Project
**East West Rail
(Western Section)
Phase 2**

Stage 2 Road safety audit response report

Offline Highways Passing Places – Package 2 – Oxfordshire (A3 Marsh Gibbon – Compound Access)

Stage 2 Road Safety Audit

Drawing Title
**PASSING PLACE A3_P_10
GENERAL ARRANGEMENT**

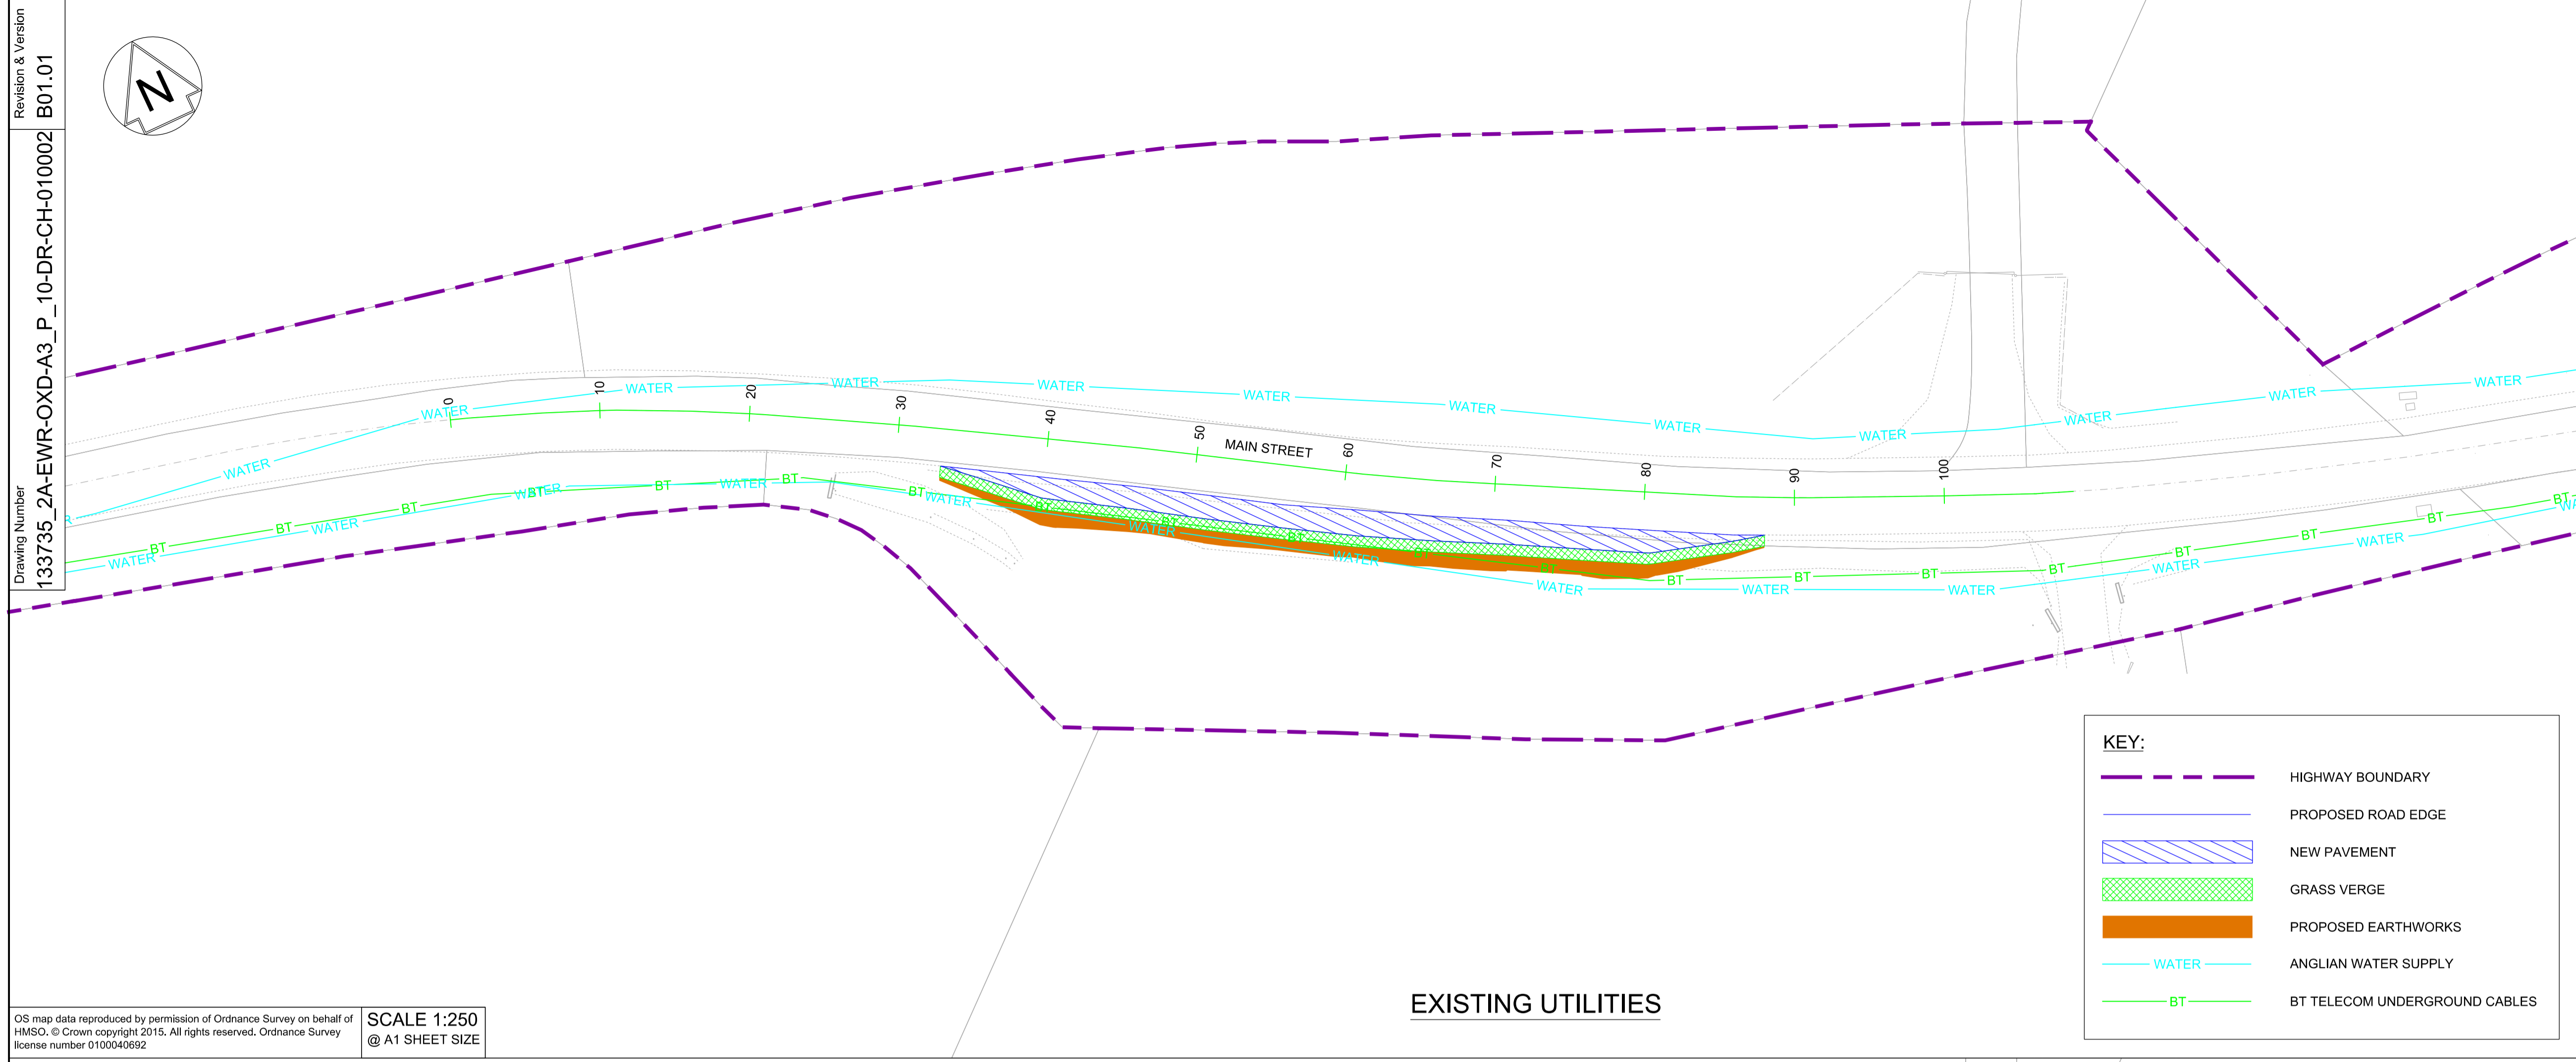
Location: Passing Places A2-P-1, A3-P-2, A3-P-3, A3-P-5, A3-P-7 and A3-P-10. Unnamed Road (towards Mill Road) and Unnamed Road.

Summary: Proximity of passing place to farm traffic access increases risk of collision. There are accesses used by farm traffic along the Unnamed Road (towards Mill Road). As a farm vehicle enters or exits these accesses from Unnamed Road (towards Mill Road), there is a likelihood that a construction vehicle may collide with it as they may not anticipate the turning farm vehicle, particularly when they are preparing to enter the passing place. This issue is exacerbated by the presence of vegetation around these accesses which reduces the visibility between farm traffic and construction drivers using the Unnamed Road (towards Mill Road).

Location: Passing Places A2-P-2, A3-P-2, A3-P-3, A3-P-4, A3-P-5, A3-P-6, A3-P-7, A3-P-8, A3-P-9 and A3-P-10.

Summary: Driver visibility reduced by vegetation

Passing places are proposed in positions where vegetation may restrict drivers' visibility of the route and the visibility of vehicles using the passing places. With this limitation, drivers of construction vehicles may not be aware that they should wait and might proceed, increasing the risk of side swipe collisions, or the risk of vehicles leaving the carriageway

RSA Ref	Location	RSA Problem	RSA Recommendation	Design Team Response	Network Rail Response	Agreed RSA action
2.4	<p>Passing Places A2-P-1, A3-P-2, A3-P-3, A3-P-5, A3-P-7 and A3-P-10. Unnamed Road (towards Mill Road) and Unnamed Road.</p>	<p>Proximity of passing place to farm traffic access increases risk of collision There are accesses used by farm traffic along the Unnamed Road (towards Mill Road). As a farm vehicle enters or exits these accesses from Unnamed Road (towards Mill Road), there is a likelihood that a construction vehicle may collide with it as they may not anticipate the turning farm vehicle, particularly when they are preparing to enter the passing place. This issue is exacerbated by the presence of vegetation around these accesses which reduces the visibility between farm traffic and construction drivers using the Unnamed Road (towards Mill Road).</p>	<p>Provide traffic signing to warn of construction passing places and farm traffic accesses. Trim back vegetation around the accesses to maximise intervisibility</p>	<p>Accept the RSA problem and recommendation made by the RSA team. The design includes a signage strategy which provides signs to notify drivers that the road has passing places. The site clearance drawings include vegetation clearance to achieve required visibility and signage strategy drawings likewise include this provision.</p>	Accepted	Proceed as Design Team Response

2.5	<p>Passing Places A2-P-2, A3-P-2, A3-P-3, A3-P-4, A3-P-5, A3-P-6, A3-P-7, A3-P-8, A3-P-9 and A3-P-10. Unnamed Road (towards Mill Road) and Unnamed Road.</p>	<p>Driver visibility reduced by vegetation Passing places are proposed in positions where vegetation may restrict drivers' visibility of the route and the visibility of vehicles using the passing places. With this limitation, drivers of construction vehicles may not be aware that they should wait and might proceed, increasing the risk of side swipe collisions, or the risk of vehicles leaving the carriageway on narrower sections of carriageway. Additionally, drivers of approaching vehicles may not anticipate the construction vehicle leaving the passing place, leading to side swipe or head on collisions. There is further risk that existing vegetation will encroach into the carriageway increasing the risk of damage to vehicles and HGVs being pushed towards oncoming traffic.</p>	<p>The existing vegetation should be cut back to ensure clear visibility to all traffic signs and to keep the carriageway clear from obstructions.</p>	<p>Accept the RSA problem and recommendation made by the RSA team. The site clearance drawings include vegetation clearance to achieve required visibility and signage strategy drawings likewise include this provision.</p>	Accepted	Proceed as Design Team Response

Drawing Title
PASSING PLACE A3_P_10 EXISTING UTILITIES AND SITE CLEARANCE

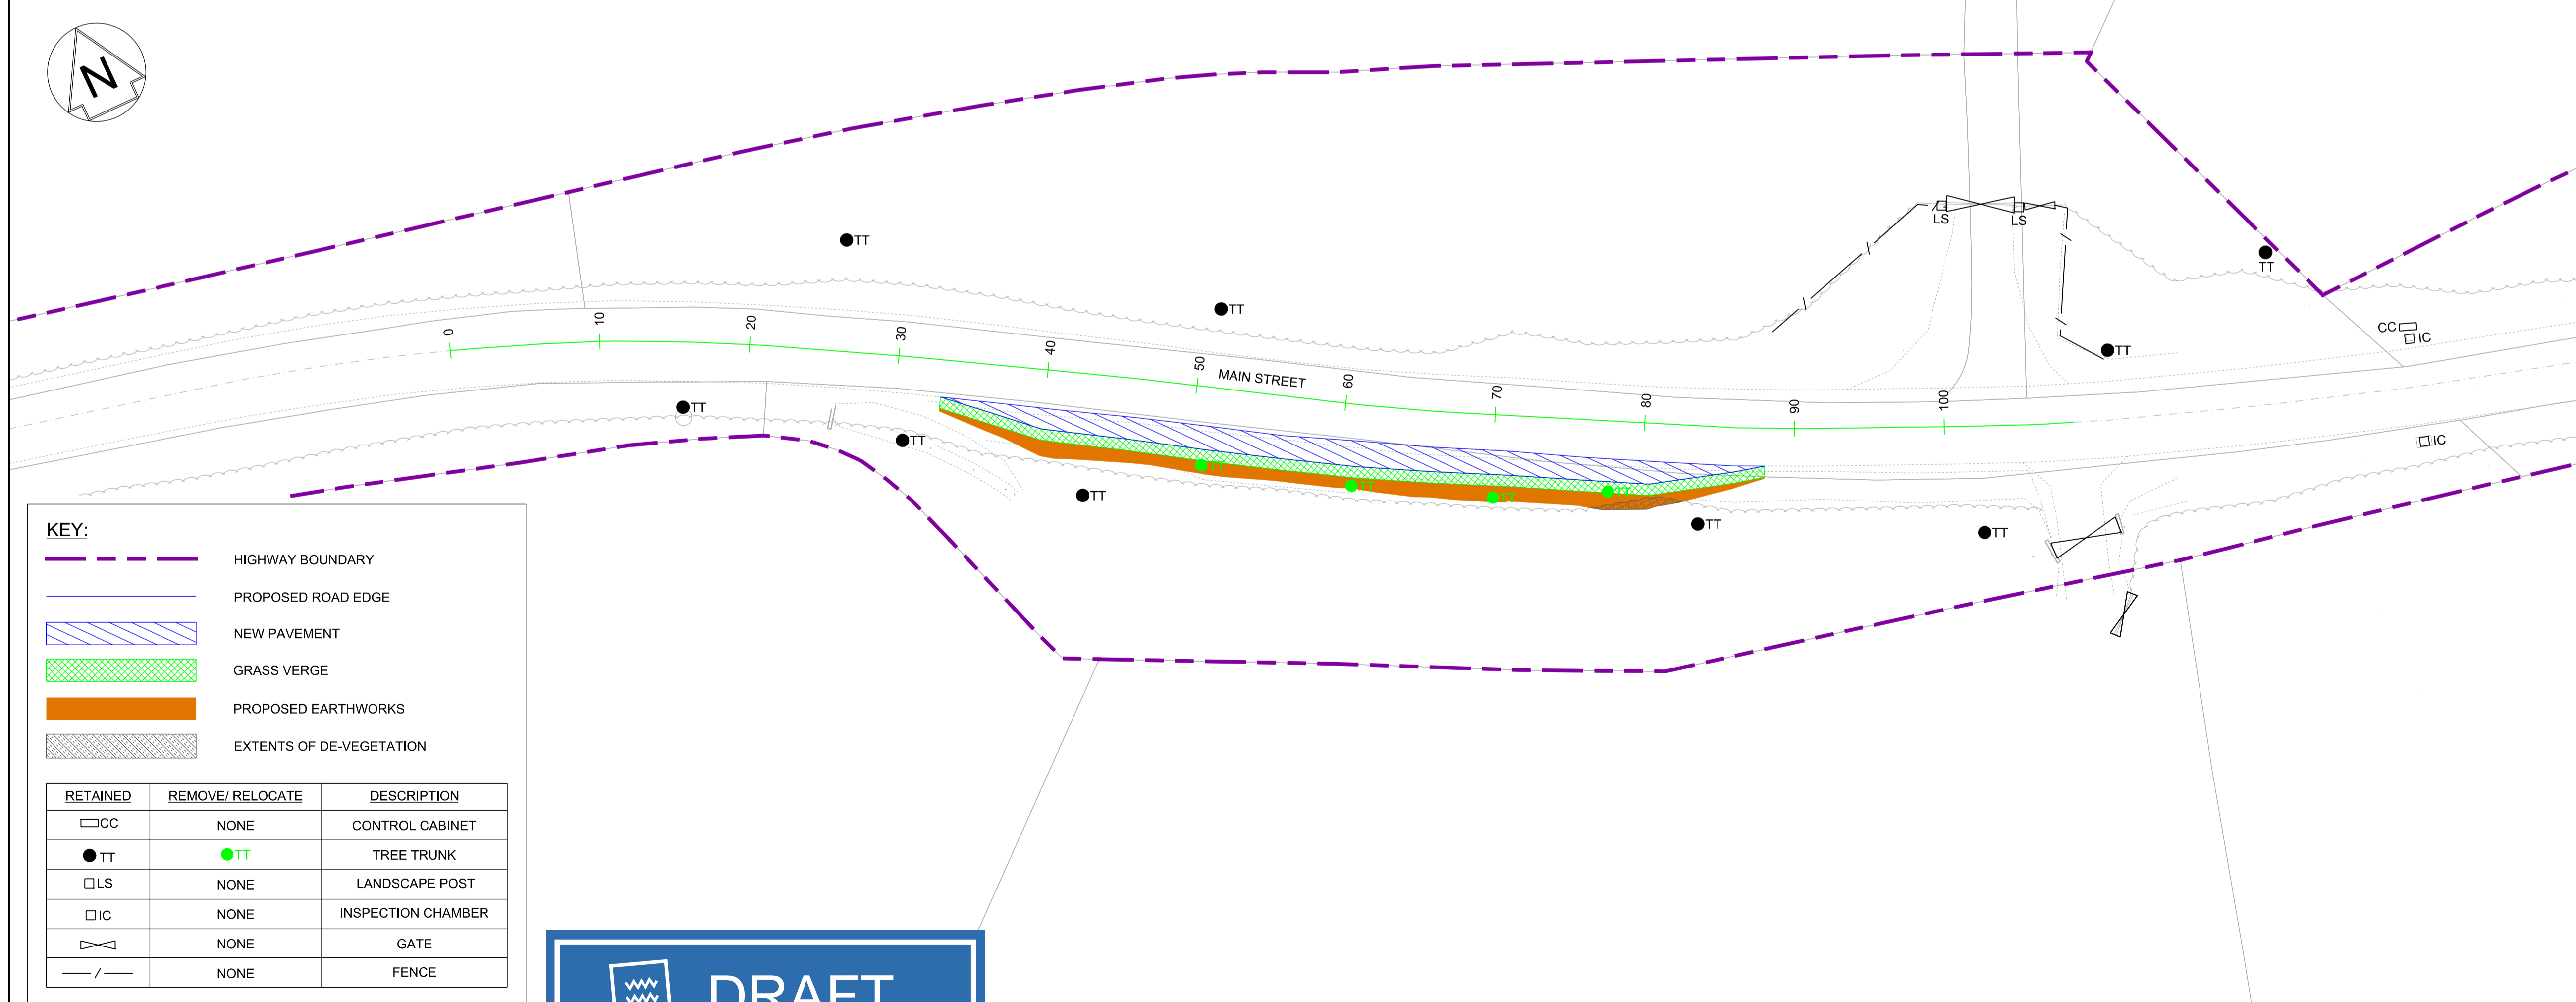
There is further risk that existing vegetation will encroach into the carriageway increasing the risk of damage to vehicles and HGVs being pushed towards oncoming traffic.

The existing vegetation should be cut back to ensure clear visibility to all traffic signs and to keep the carriageway clear from obstructions.
